IN THE UNITED STATES PATENT AND TRADEMARK OFFICE

Serial No.: 10/375,232

Title: YOGA SUPPORT SYSTEM AND METHOD

REPLY TO OFFICE ACTION DATED MAY 21, 2003

Fig.3A

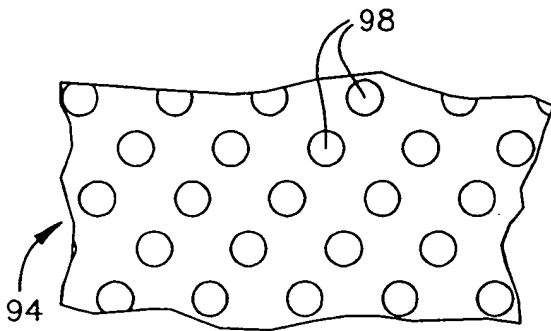
A replacement drawing sheet is enclosed herewith, adding Fig. 3A to overcome examiner's objection to the drawings.

The drawings stand objected to under 37 CFR 1.83(a). As noted above, a replacement sheet of drawings is submitted herewith, rendering moot the objection. Withdrawal of the objection is therefore respectfully requested.

Fig. 3A is a cross-sectional view showing an anti-skid portion attached to a fabric underlayer of the glove of Fig. 2;

The glove anti-skid material portion 22 may include an anti-skid material attached to an underlying fabric 93, for example, being adhesively attached with a suitable adhesive, as illustrated in Fig. 3A. Alternatively, or in addition, the glove anti-skid material portion 22 may be attached to an underlying material by other suitable means, for example, by stitching. The glove anti-skid material portion 22 may include any of a variety of suitable materials that provide an increased coefficient of friction, thereby preventing or discouraging sliding when the anti-skid material is pressed against the surface. Examples of suitable anti-skid materials include polyurethane foam, leather, and rubber.
